Statement of Work

Procedure to rework 151X1225DF01PC02 due to false De-sat

151X1225DF01PC02 or 104W4708P002

3.3 Remove coating of Capacitors (C34, C35, C44, C60)

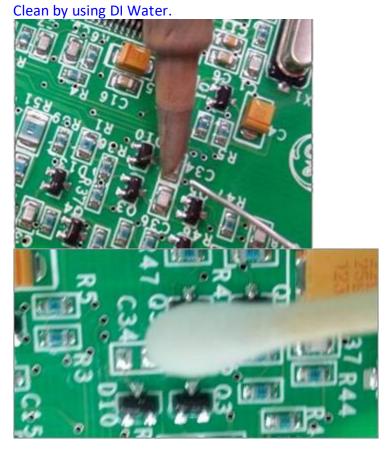
Use ESD bar to scrape the conformal coating.

Clean by ESD ionizer.

Use Industrial alcohol to clean the board area.

Clean by using DI Water.

3.4 Remove Capacitors (C34, C35, C44, C60)

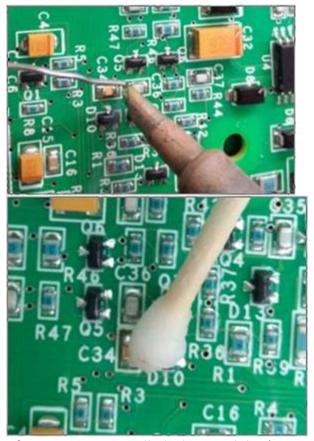
Remove capacitors by solder iron.
Use Industrial alcohol to clean the board area.

3.5 Conformal Coating Capacitors (C34, C35, C44, C60)

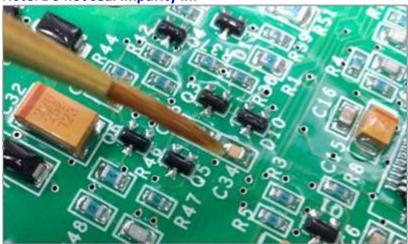
Use brush to coating the oil at the specifically area. Use heat gun to heat up for coat frozen.

Note: Do not seal impurity in.

3.6 Label & Assemble

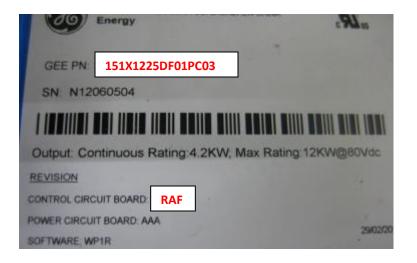
Put label "352A1123P1RAF" to reworked WPCCC card.

Mark reworked board with "V" on part PL2.

Change module label PN marking from 151X1225DF01PC02R0 to $\underline{\textbf{151X1225DF01PC03}}$; 'CONTROL CIRCUIT BOARD' from RAE to $\underline{\textbf{RAF}}$.

Add module label PN marking 104W4708R003 on the side cover.

Schematic

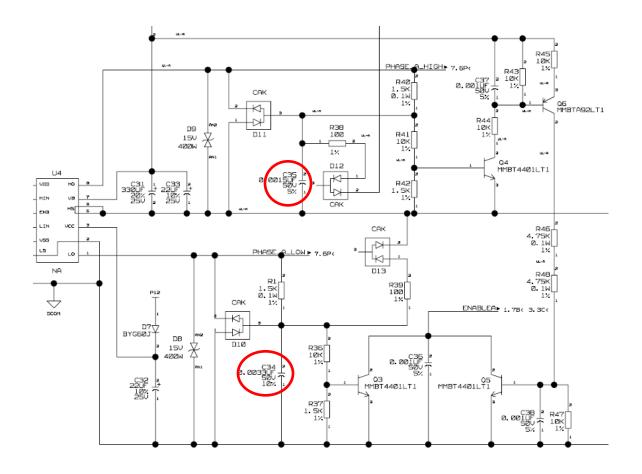
This method (<u>replacing C34, C35, C44, C60 with 0.0047uF caps</u>) need to be verified at wind sites, before formal release.

C34, C35 in Bridge/Phase A De-sat detection circuitry

C44, C60 in Bridge/Phase B De-sat detection circuitry
